Re: Turkey Point Unit 3
Docket No. 50-250
ECCS Information

Re: Turkey Point Units 3 and 4
Docket Nos. 50-250 and 50-251
ECCS Information Request

Turkey Point Units 3 and 4
Docket Nos. 50-250 and 50-251
ECCS Information Request

Re: Turkey Point Units 3 and 4
Docket Nos. 50-250 and 50-251
ECCS Information

FIGURE 1

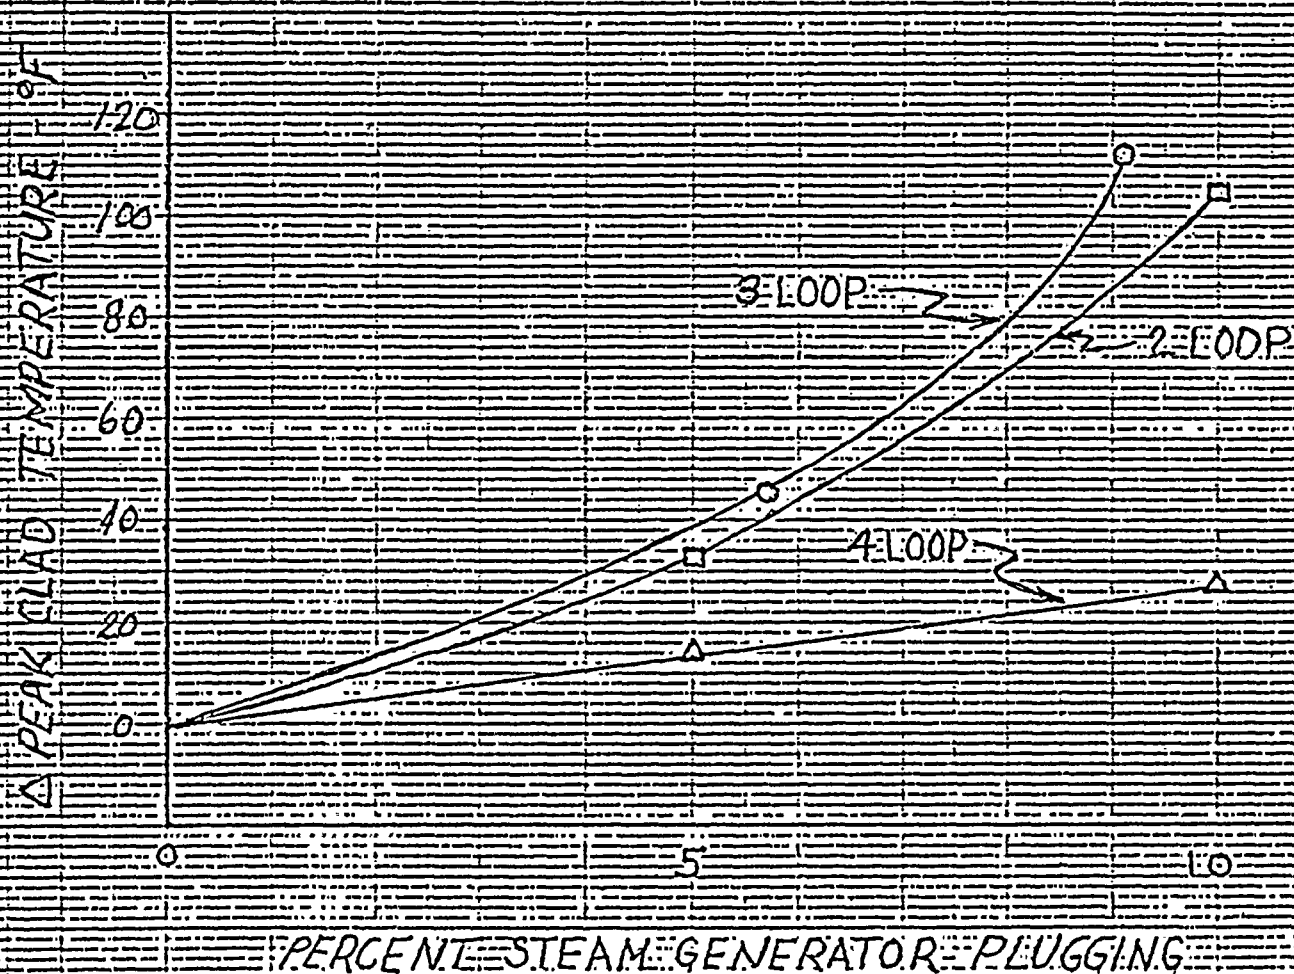
ECCS information applicable to Turkey Point Units 3 and 4 was submitted to you on February 2, 1977 (L-77-38). Figures 1 and 2 of that submittal were in error. Revised Figures 1 and 2 are attached. The conclusions derived from the original figures remain unchanged.
